1980 LTD

PARTS DIAGRAM

VALVES

Ref. Nos. 3 & 4, Valve Springs

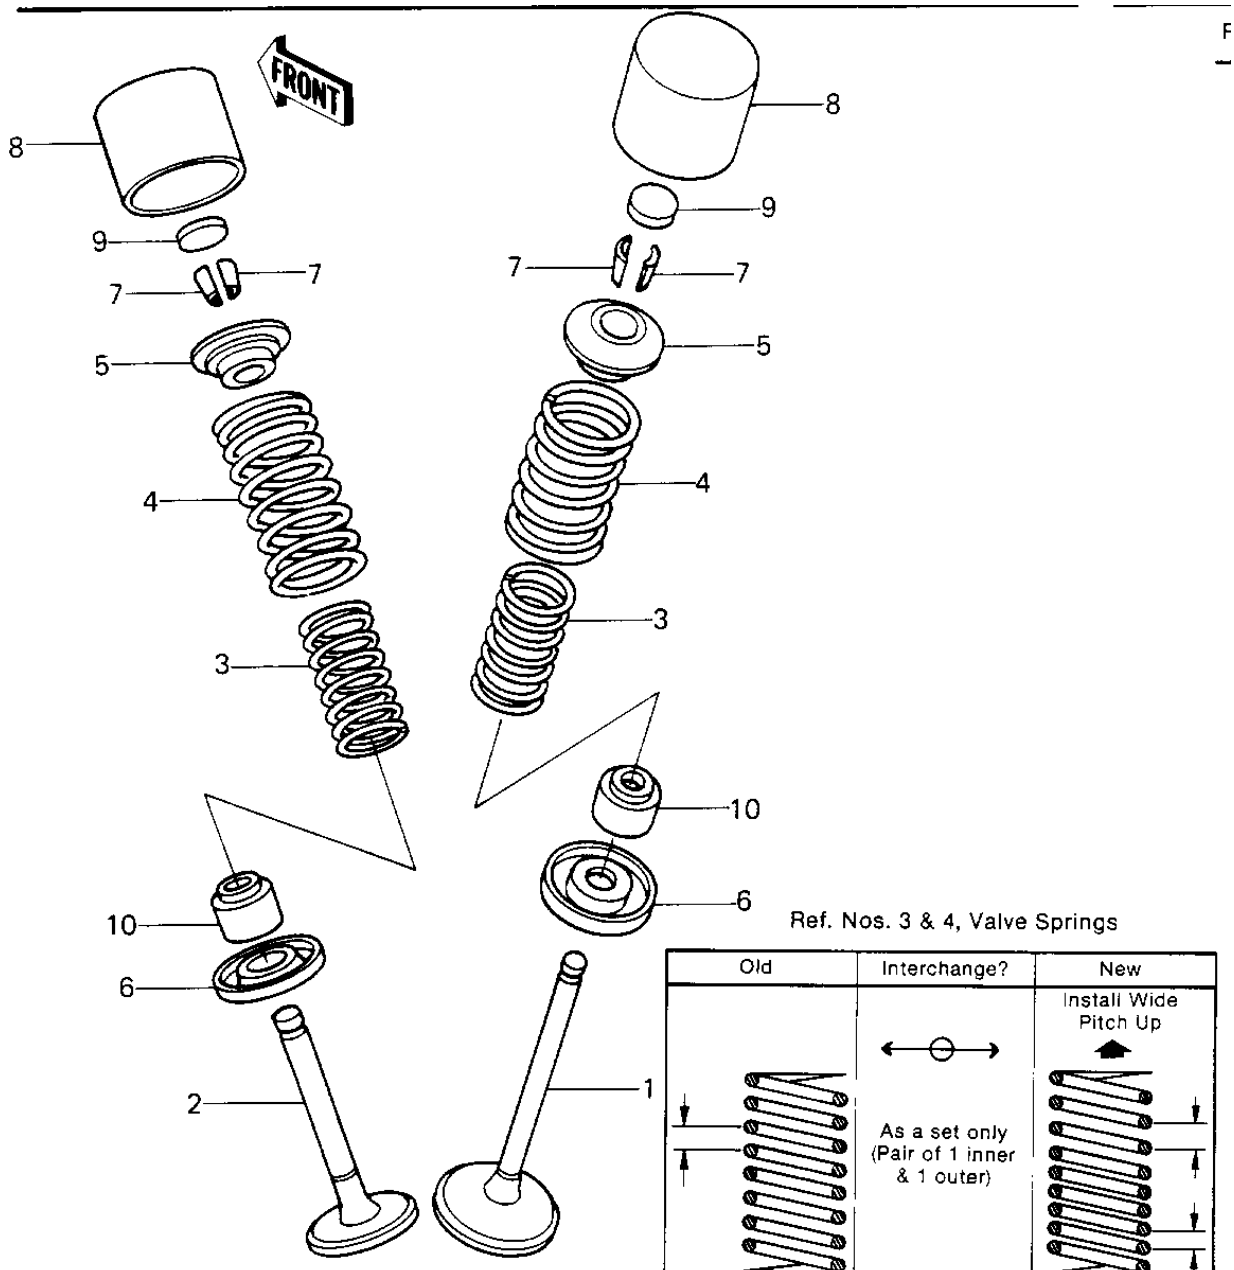
Old	Interchange?	New
	As a set only (Pair of 1 inner & 1 outer)	Install Wide Pitch Up

Identification		
Inner	12007-011	49078-1001
Outer	12007-012	49078-1002
Remarks	Constant Pitch	Dual Pitch
E/No.	026001~029615	029616~032216
